SERVICE BULLETIN

TITLE: Replacement of "Click" Washer in Fuel Valve

BULLETIN NO. 250

MODELS AFFECTED: 108 (Voyager and Flying Station Wagon - 165 H.P.) Serial Numbers 108-2250 through 108-2652

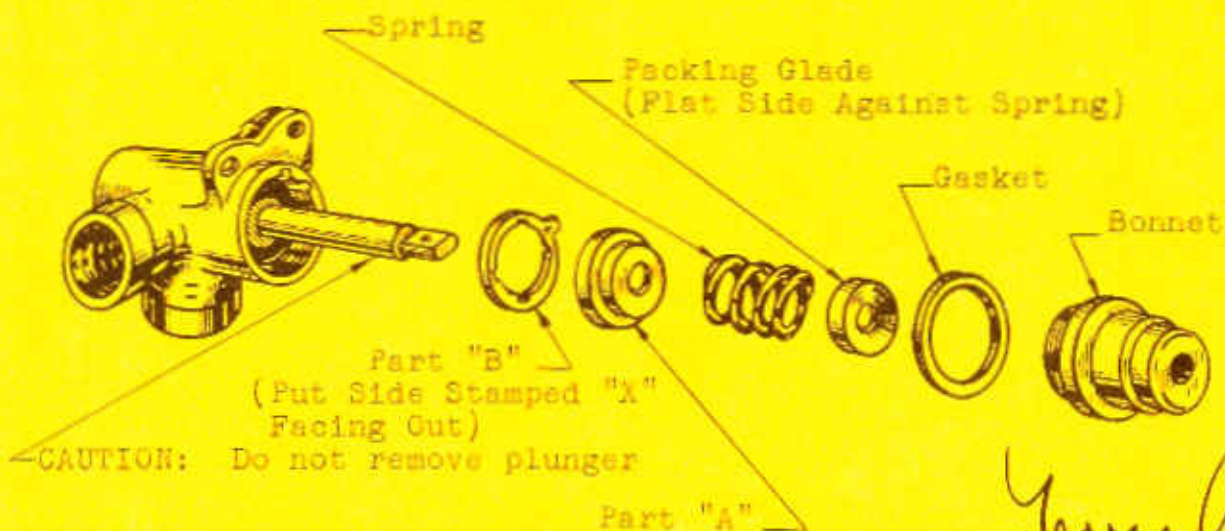
In order to restore the position locating feature in the fuel tank selector valve and assure positive operation of the valve at all times, it is recommended that the subject replacement be made in all 165 horsepower Voyager and Flying Station Wagon airplanes within the serial numbers noted above.

Necessary parts, marked "A" and "B" on Figure 1, are being forwarded under separate cover without charge.

Drain the fuel from both tanks and drain the fuel lines at the strainer on the firewall. Disconnect control shaft from fuel valve. Remove bonnet from valve and disassemble valve to the extent shown in Figure 1. Parts "A" and "B" are to be replaced with the new parts furnished. Reassemble valve and attach control shaft. When reinstalling part "B" position the tab in the groove off-set to the right. The side of the washer marked "X" should face out of the valve. **IT IS IMPORTANT THAT THE TAB BE INSTALLED IN THE GROOVE OFF-SET TO THE RIGHT OTHERWISE THE VALVE POSITION INDICATOR WILL NOT INDICATE CORRECTLY.**
